Access Compliance Report

Public Rights-of-Way

Intersection ID: 10023890	Main Street: COMMUNITY_HOUSE_RD	Cross Street: N/A	Location:	E
ADA ID: 99E71E00BEC1	Ramp Type: Perp	Initial Pass/Fail: Fail	Overall Compliance: No	Severity Score: 25

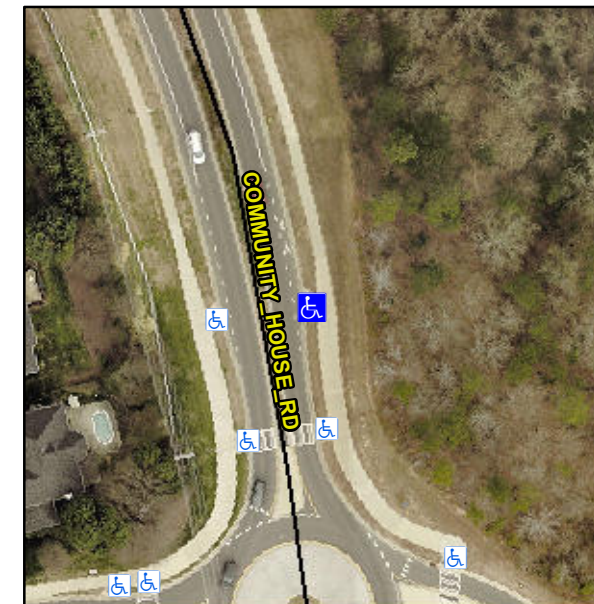
Not Found, R304.2.2

Compliance	Description	Data	Compliance	Description	Data
N/A	Ramp Length (in)	72.0	No	Ramp Slope (%)	13.0
Yes	Ramp Width (in)	88.0	Yes	Ramp XSlope (%)	0.2
N/A	Flare Type LT	N/A	N/A	Flare Type RT	N/A
N/A	Flare Slope LT (%)	N/A	N/A	Flare Slope RT (%)	N/A
N/A	Flare Traversable LT?	N/A	N/A	Flare Traversable RT?	N/A
N/A	Landing Length (in)	N/A	N/A	DWS Provided?	N/A
N/A	Landing Width (in)	N/A	N/A	DWS Contrast?	N/A
N/A	Landing Slope (%)	N/A	N/A	DWS Length (in)	N/A
N/A	Landing X Slope (%)	N/A	N/A	DWS Full Width?	N/A
N/A	Landing Curb? (Y/N)	N/A	N/A	DWS Offset (in)	N/A
N/A	Shared Landing?	N/A			
N/A	Gutter Ponding?	N/A	N/A	Gutter Slope (%)	N/A
N/A	Gutter Lip Ht (in)	N/A	N/A	Gutter X Slope (%)	N/A
N/A	Painted X Walk1?	No	N/A	Painted X Walk2?	N/A
	X Walk 1 Direction	To W		X Walk 2 Direction	N/A
N/A	X Walk 1 Width (in)	N/A	N/A	X Walk 2 Width (in)	N/A
	X Walk 1 Slope (%)	1.7		X Walk 2 Slope (%)	N/A
	X Walk 1 X Slope (%)	0.8		X Walk 2 X Slope (%)	N/A

Remove & Replace Entire Ramp.
